PCN – Process Change Notification

Change:	G30.B and MA140 series
Date:	2016/05/25
Author	Haley Tsai

Illustration of Change (G30.B & MA140 series)

**New drawing
(Add step inside the bottom housing)**

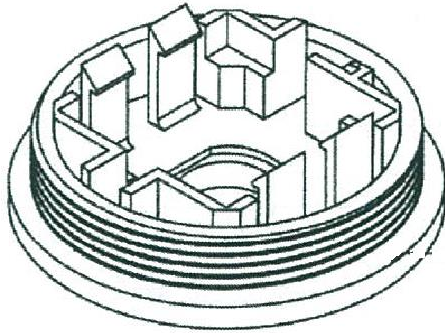
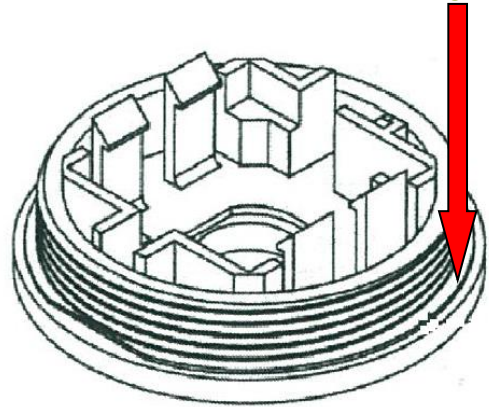
1. A step was added inside the bottom housing to ensure a tighter assembly.
2. Extended the screw thread on the new design of the bottom housing to make the assembled product more stable.
3. Added a fixing screw at the bottom of the housing to make antenna more stable.
